NOTICE OF OPEN MEETING
AGENDA
PLANNING AND ZONING COMMISSION
City of Moberly
City Council Chambers – Moberly City Hall
101 West Reed Street
October 31, 2022
6:00 PM

Subject: Agenda item 1, Site Plan Review located at 500 W Rollins St

Re: P&Z Submittal Letter for “500 West Rollins Street”

Conceptual Site Plan for 500 West Rollins

CSP CONCEPTUAL SITE PLAN
SCALE: 1" = 20'

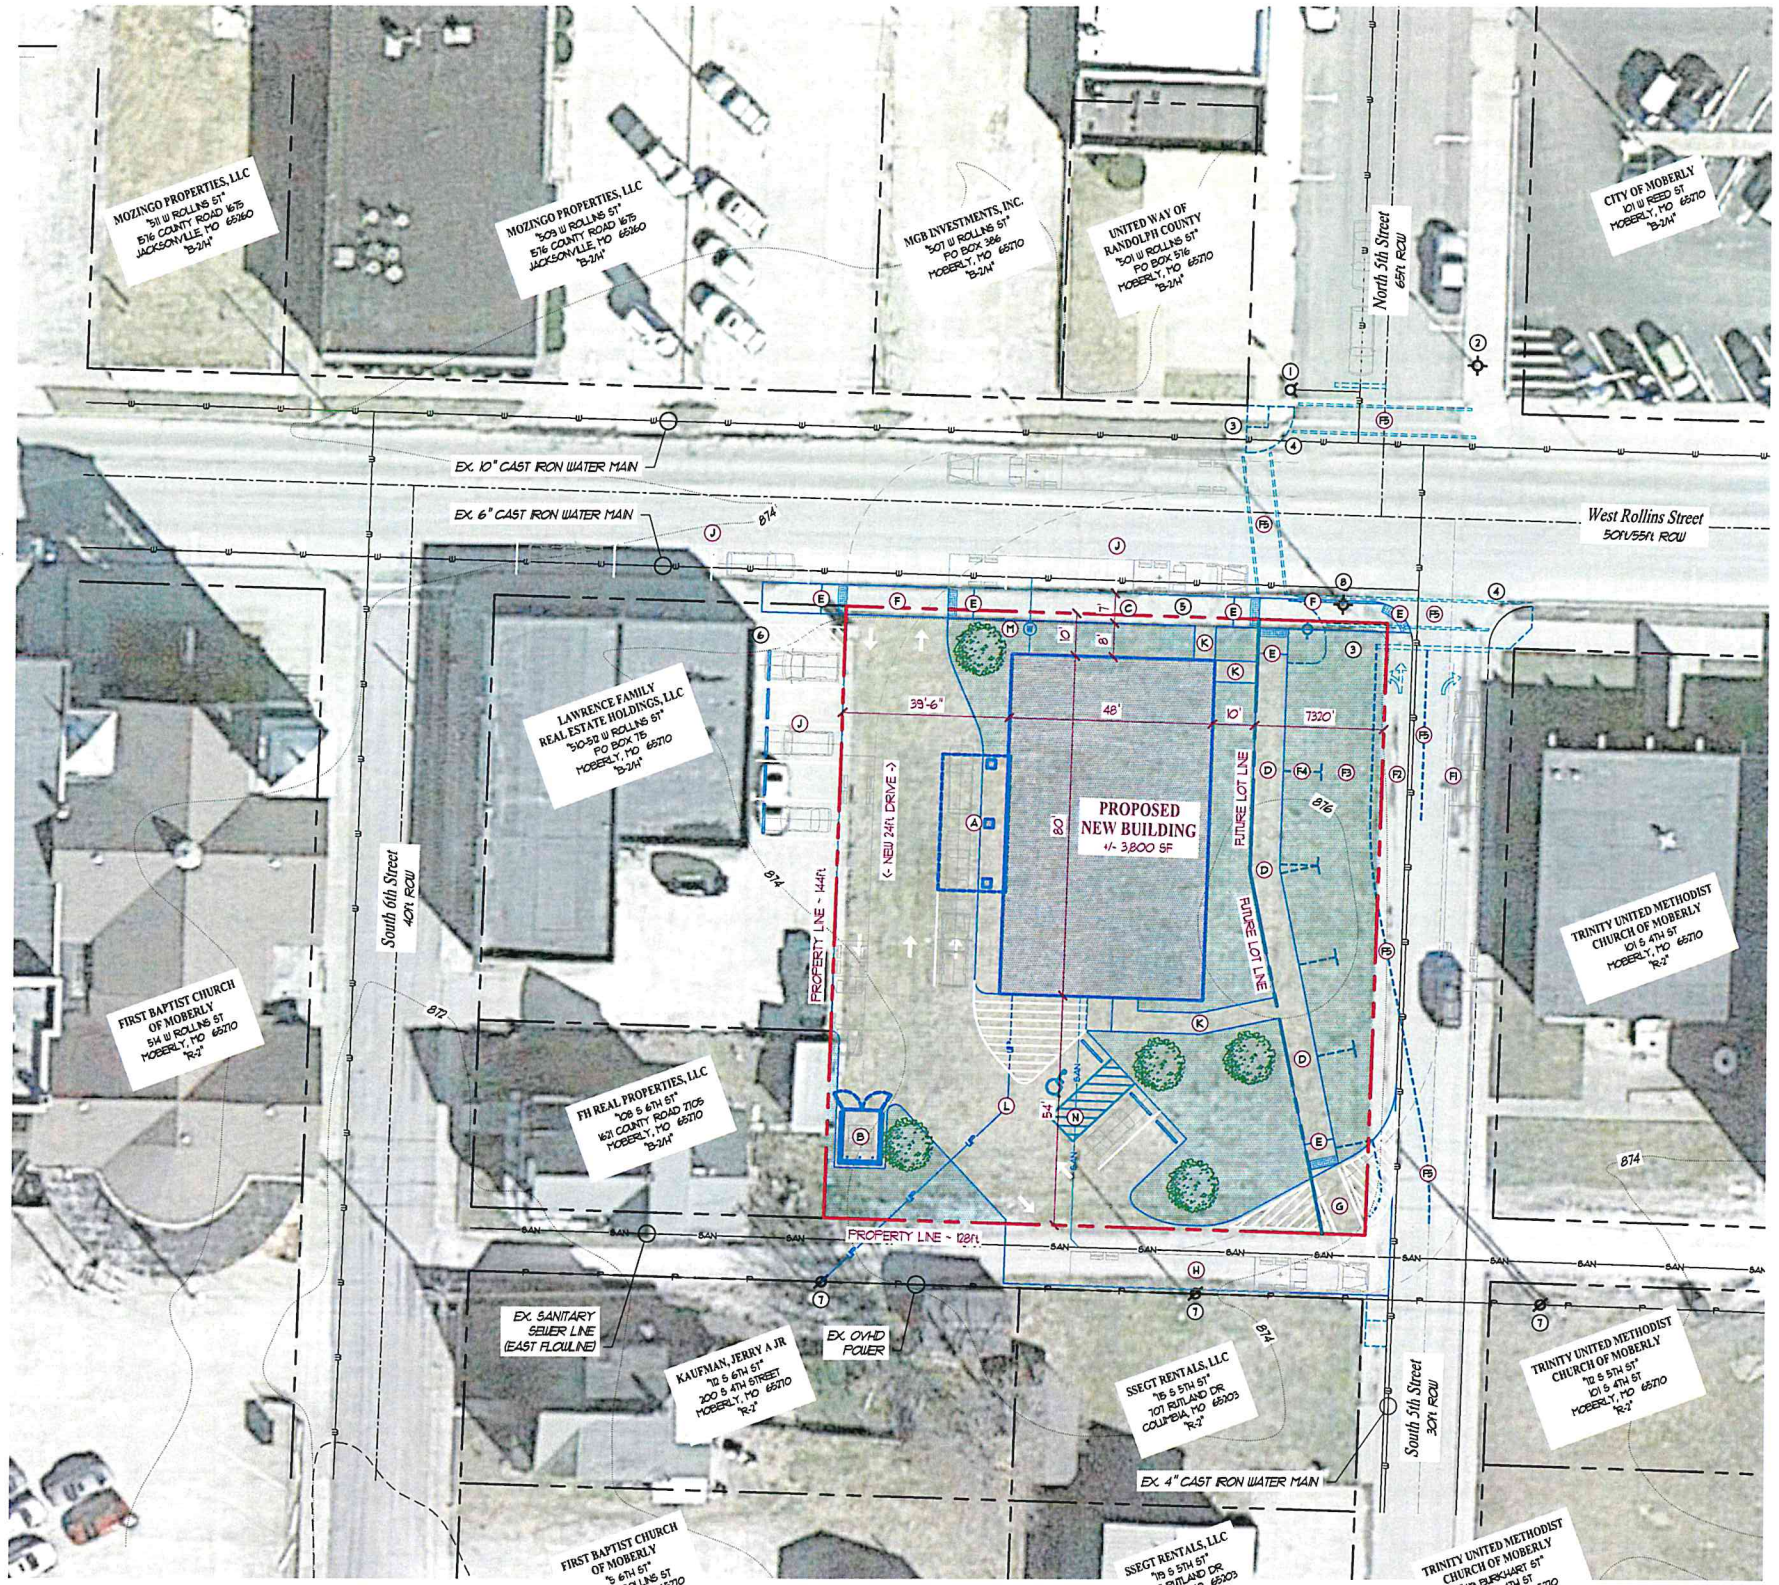
The presented site plan is for new business building located at 500 W Rollins St as a new development. The site plan includes parking access both in a lot as well as along a re-routed 5th Street at the current location. The City of Moberly and the design team have reached a mutually agreeable plan for the intersection to improve traffic and minimize hazards due to the increased traffic related to the prospective business. This includes aligning the north and south side of W Rollins and 5th Street intersection as well as adding on street parking along the west side of 5th street. This will open the intersection and improve traffic traveling through this intersection especially turning from 5th street onto Rollins St. Additional parking is provided in a parking lot and adequate landscaping is provided in the site plan. The use agrees with the surrounding buildings and land and is fully compliant with the zoning district in which the building is located.

The site plan presented to the Planning and Zoning Commission meets the intent and design for the area as a part of both development cohesiveness as well as improvements to traffic related issues currently at the intersection. Staff recommends approval of the site plan as presented
